**SUBJECT:** Savannah River Site's Responses to the Regulatory Comments on the 2016 Annual Comprehensive TNX Area Groundwater Monitoring and Remedial Action Effectiveness Interim Report (U) (SRNS-RP-2017-00302, Revision 0, June 2017) CERCLIS Numbers: 21, 29

**SRS Responses to SCDHEC Comments on the  
2016 Annual Comprehensive TNX Area Groundwater Monitoring and Remedial Action  
Effectiveness Interim Report (U), CERCLIS Number: 21, 29, SRNS-RP-2017-00302,  
Revision 0, Dated June 2017, Savannah River Site, Aiken, South Carolina**

**SRS Responses to USEPA Comments on the  
2016 Annual Comprehensive TNX Area Groundwater Monitoring and Remedial Action  
Effectiveness Interim Report (U), CERCLIS Number: 21, 29, SRNS-RP-2017-00302,  
Revision 0, Dated June 2017, Savannah River Site, Aiken, South Carolina**

Comments Received 11/17/2017

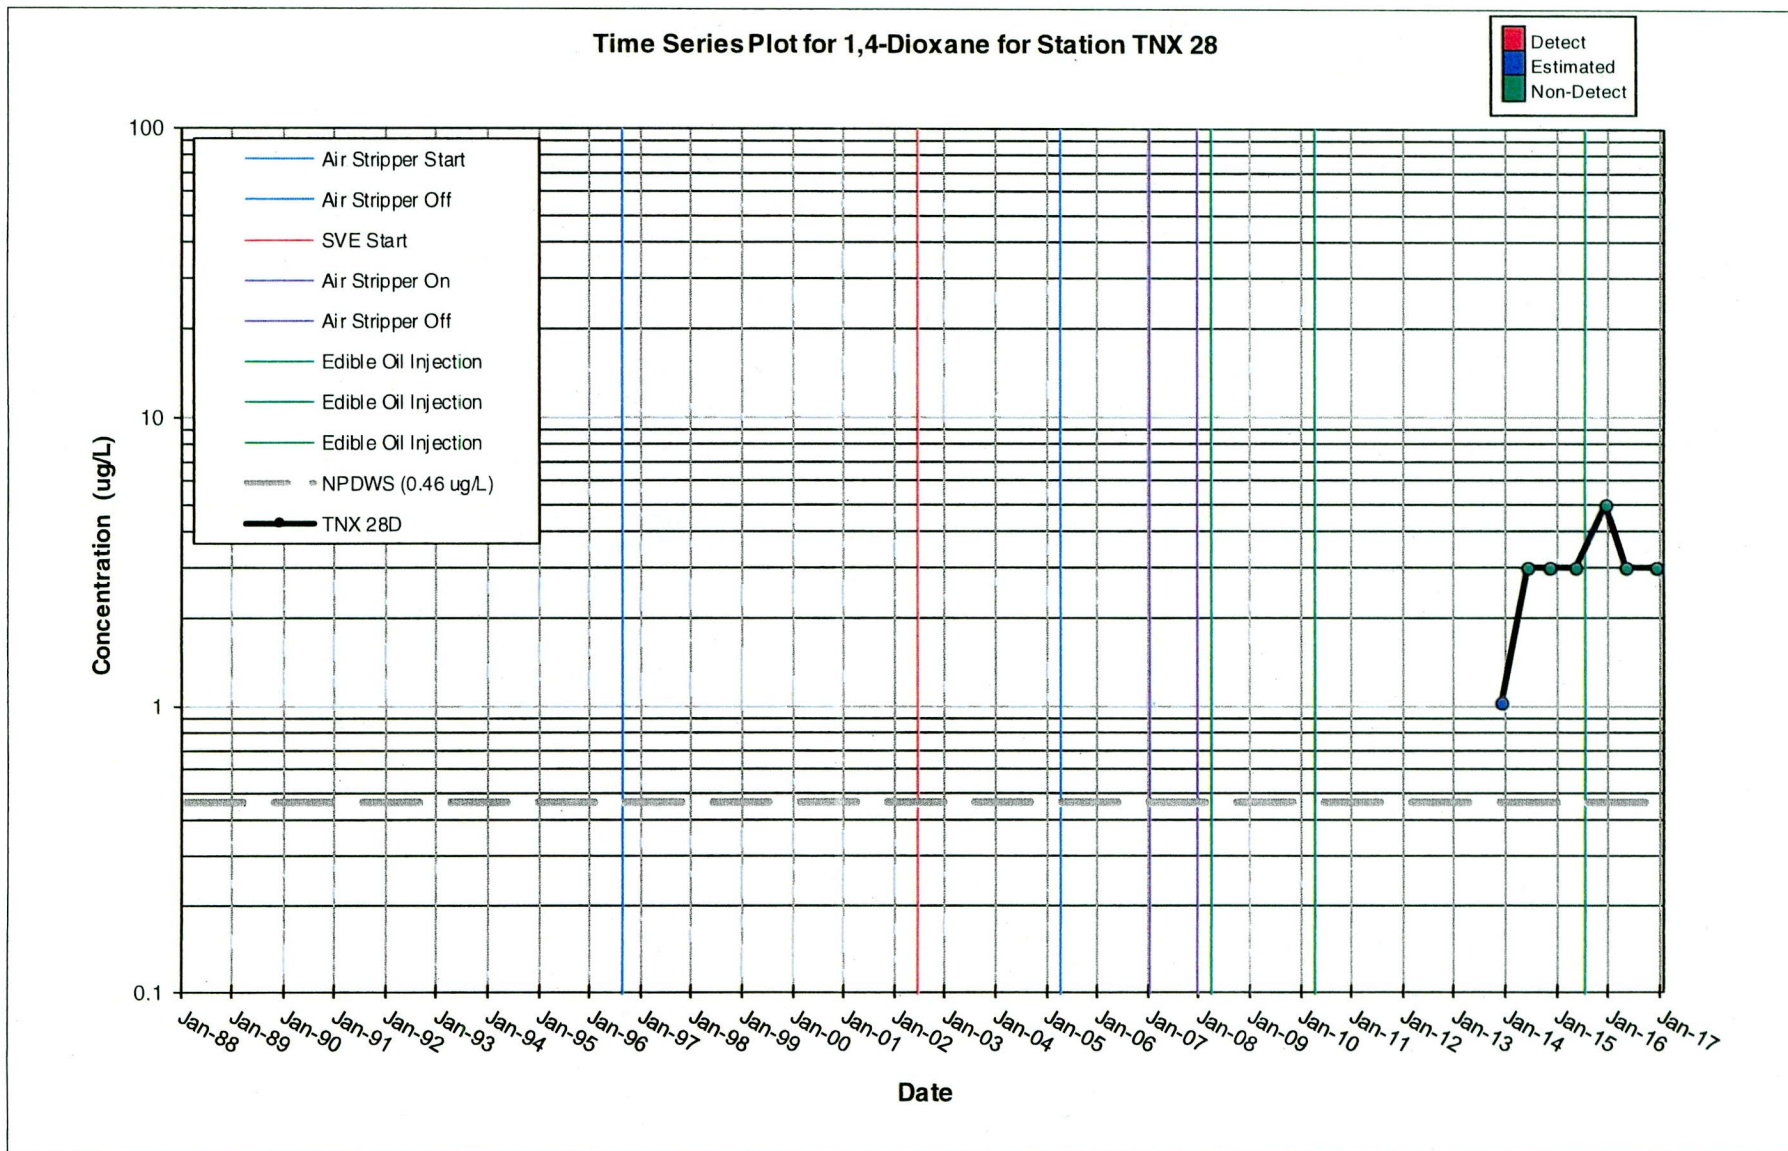
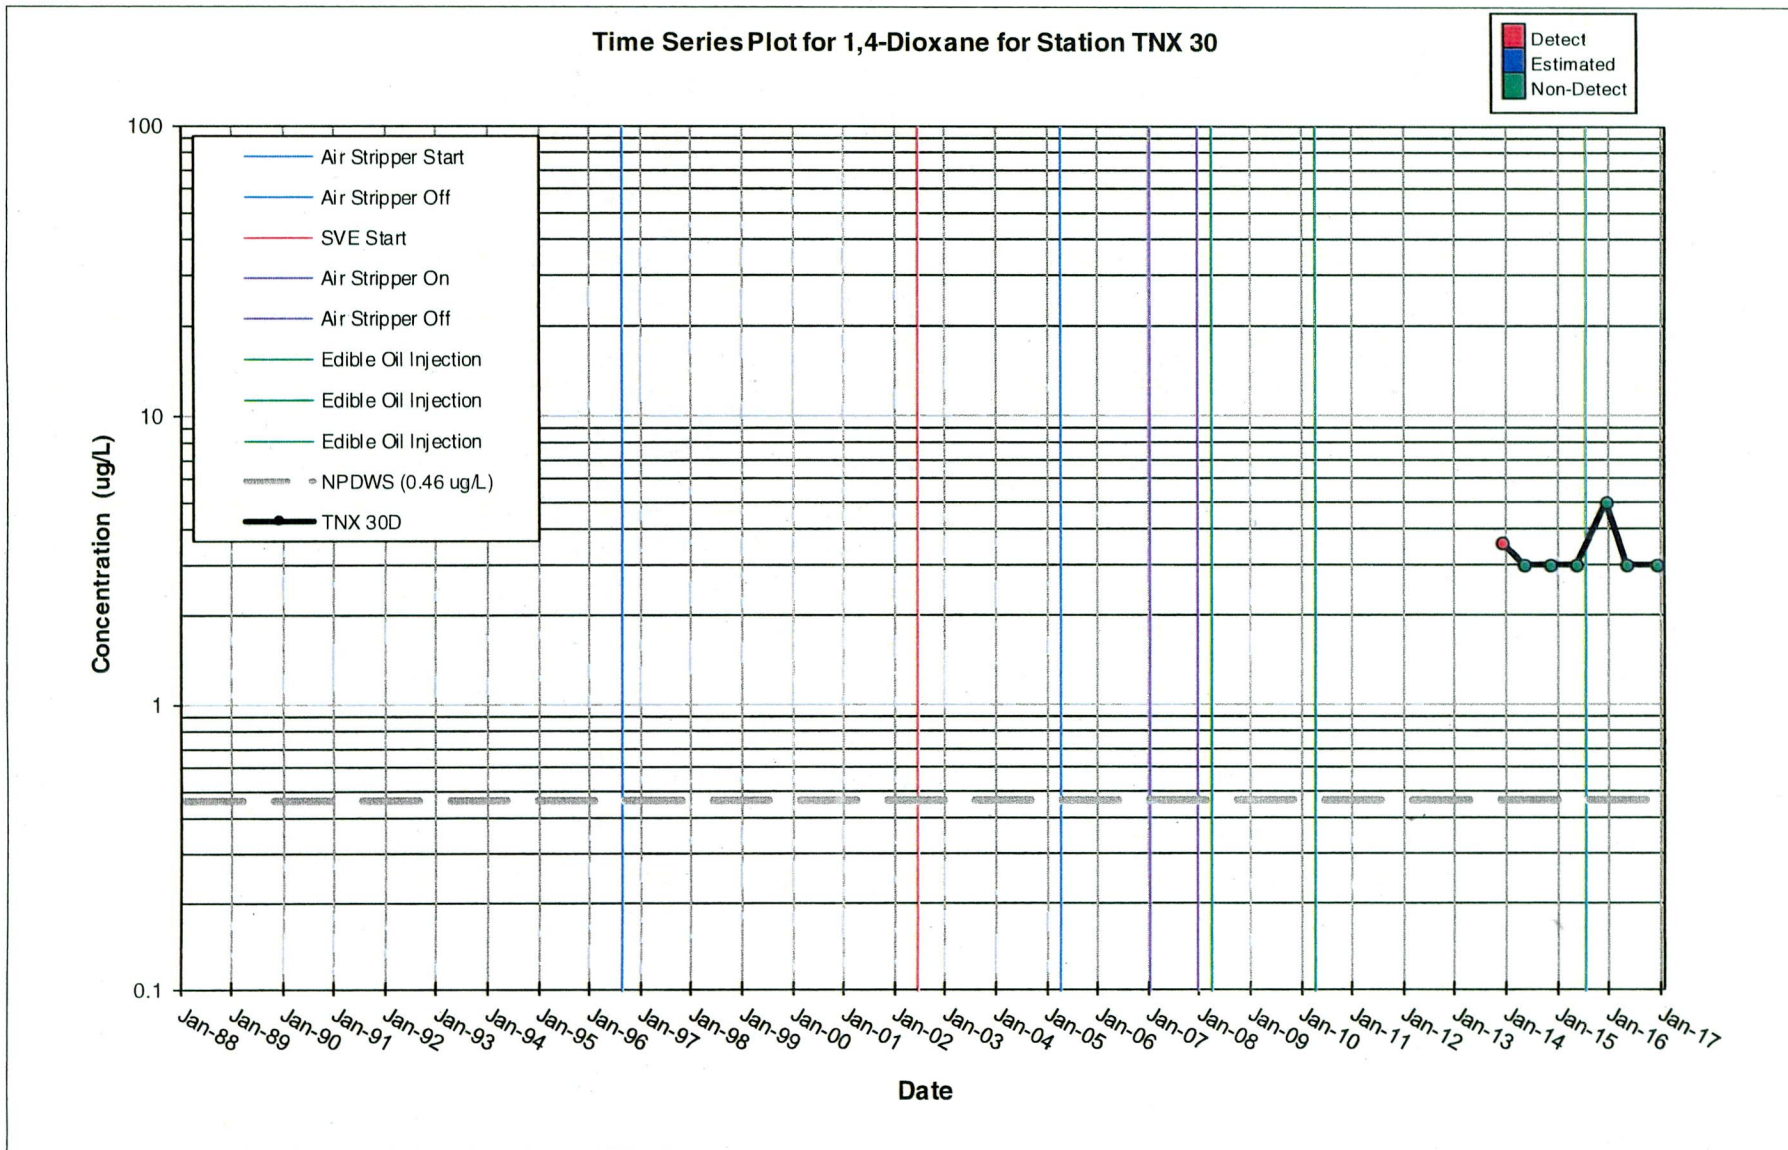
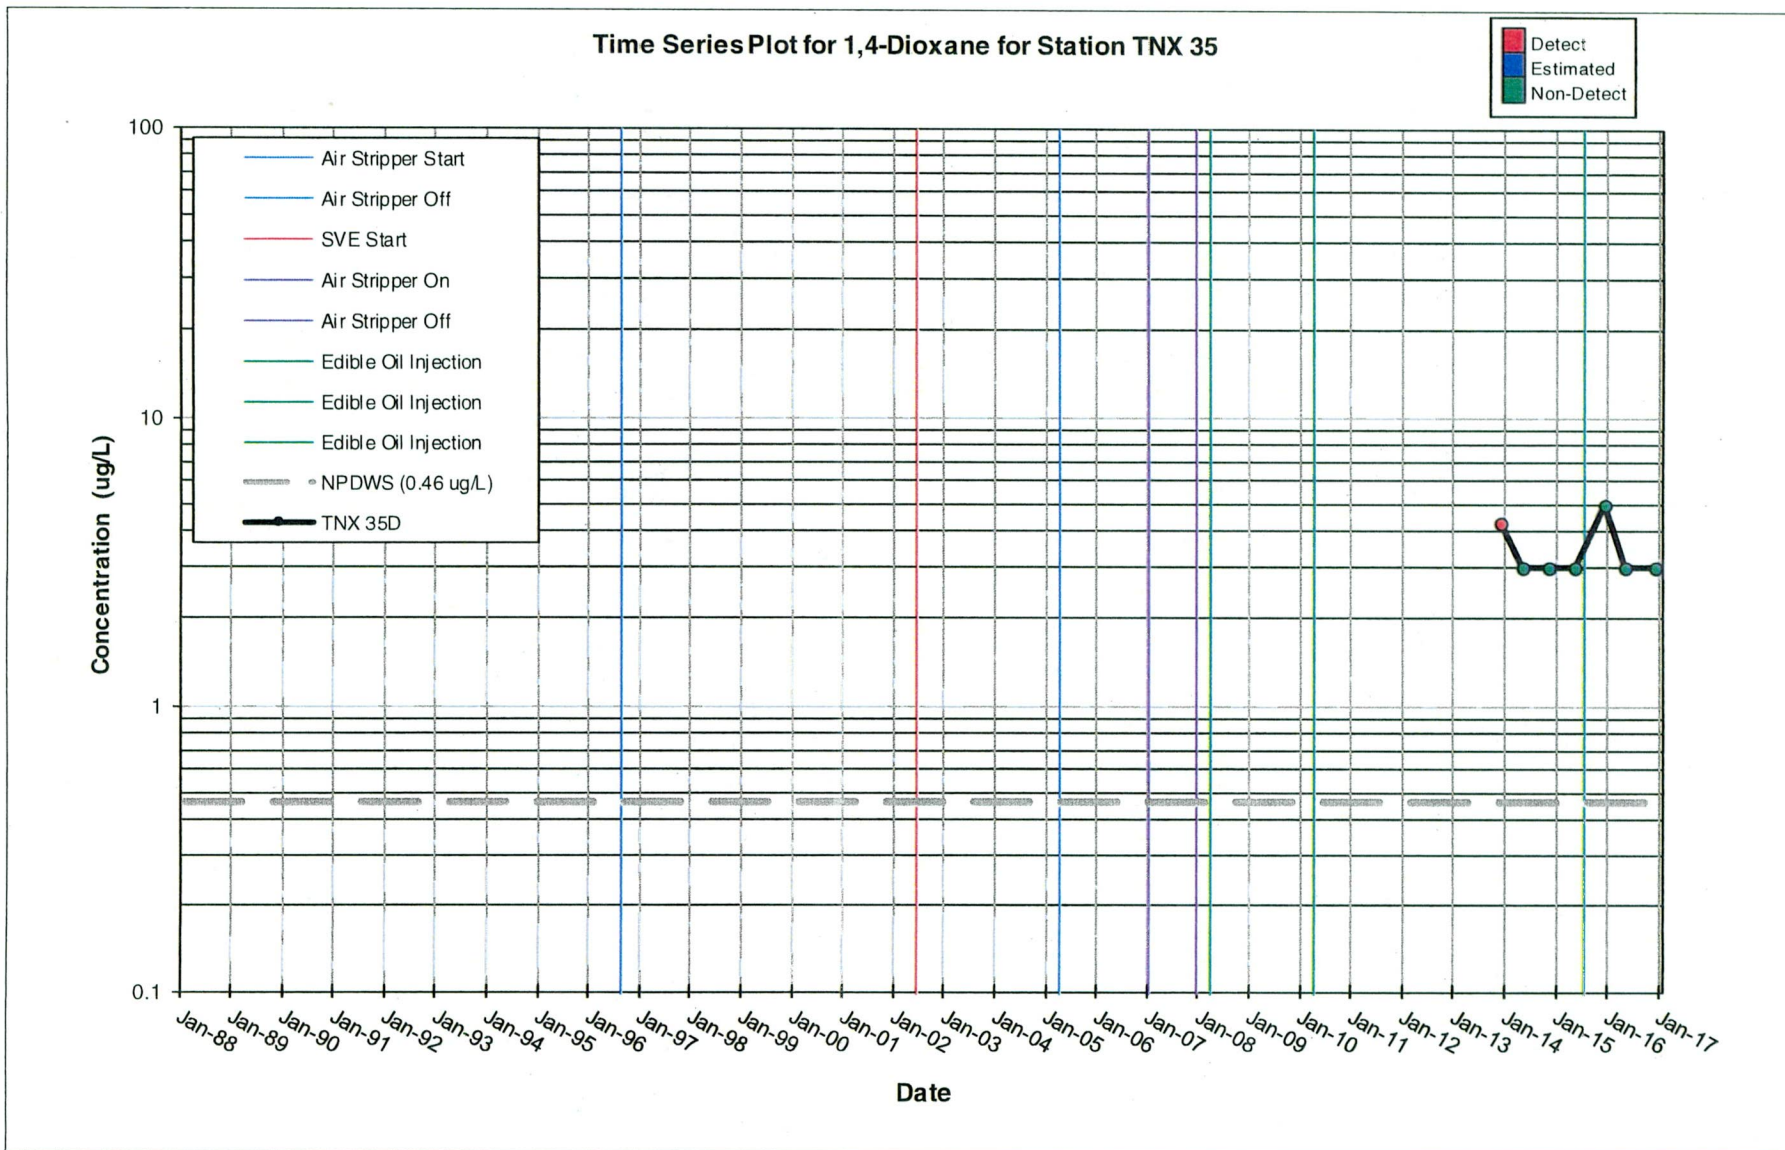
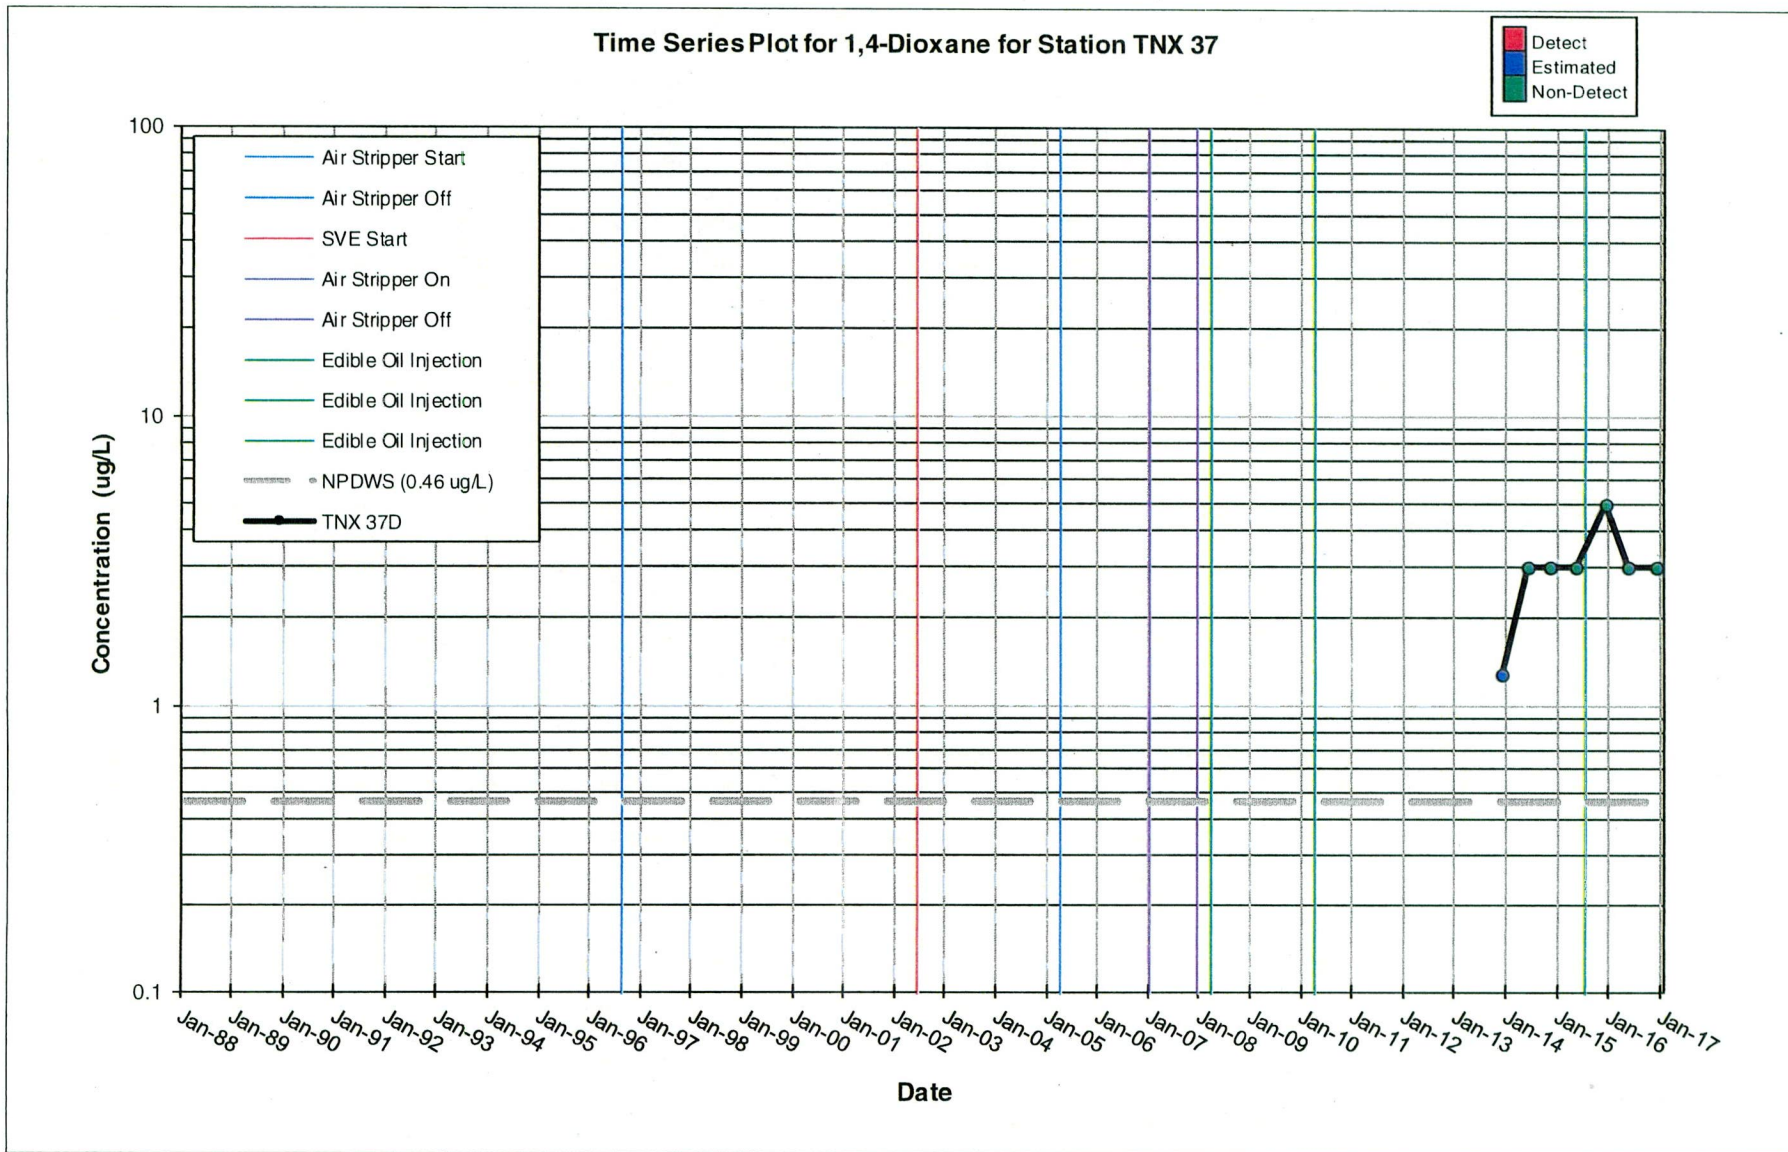
3. **Section 6.7, 1,4-Dioxane, Page 39-40 of 52:** Section 6.7 states, "1,4-Dioxane was initially sampled at all TNX Area OU monitoring wells during the fourth quarter 2013 sampling. Thirty of the 38 monitoring wells had a detection of 1,4-dioxane. The detections were scattered across the TNX Area OU including the background and monitoring wells upgradient of the source areas. It is not apparent why 1,4-dioxane concentrations were detected in almost every monitoring well. Since 2014, 1,4-dioxane concentrations have been less than the detection limit at all wells except TBG 5." However, the data from the fourth quarter 2013 and subsequent sampling events is not included in the report as a supporting line of evidence. Please revise the 2016 Annual Report to include historical groundwater data (including the laboratory detection limits), for 1,4-dioxane along with the additional constituents and parameters sampled for in subsequent sampling events.

The CD submitted with the 2016 Annual Report includes matrix tables from Appendix B. Time series graphs will be added to Appendix E of the 2017 Annual Report to display the historical 1,4-dioxane results for the monitoring well network (Attachment 2). No changes are proposed for the 2016 Annual Report.
